# STAFF REPORT

RE: 916 Elizabeth Street (permit application # T2019-0412)

FROM: Karen DeMaria, City of Key West Urban Forestry Manager

Alternative sidewalk

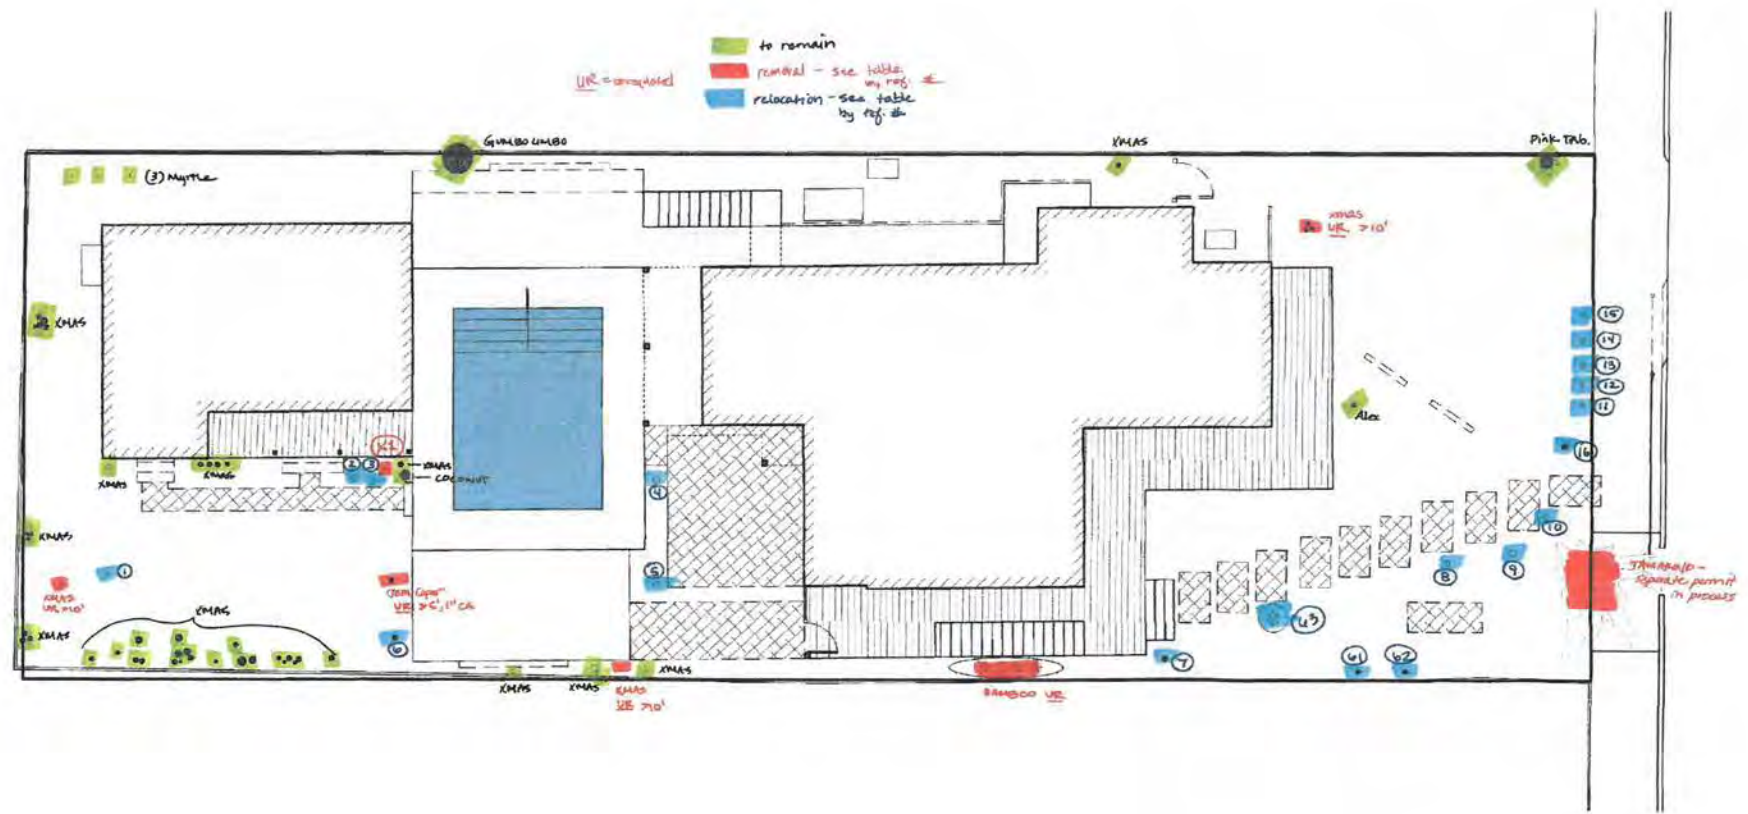
\*\*NOTE: Additional information is still needed to make a full evaluation of the tree removal application. Information from the City of Key West engineering department is needed regarding impacts to the sidewalk and roadway and whether there are

reasonable alternatives for access and information is needed from Keys Energy regarding the utility lines.

I agree with John. The main issue will be to make sure we have enough roadway and turn area for the vehicles with the driveways. I think it may be better to remove the parking, and do the bumpout but don't let me influence your decision.

From the photos, it may require the take of up to two parking spaces in order to make it the ADA access work. I will go out and take a look and let you know my opinion.

It is possible to "bump out" a sidewalk around the tree. It will come at the expense of two automobile parking spaces. I believe there is space available to add more scooter/bike parking, so the loss of parking is somewhat mitigate for alternative vehicle parking. I do not currently have a time frame for when this can be implemented.
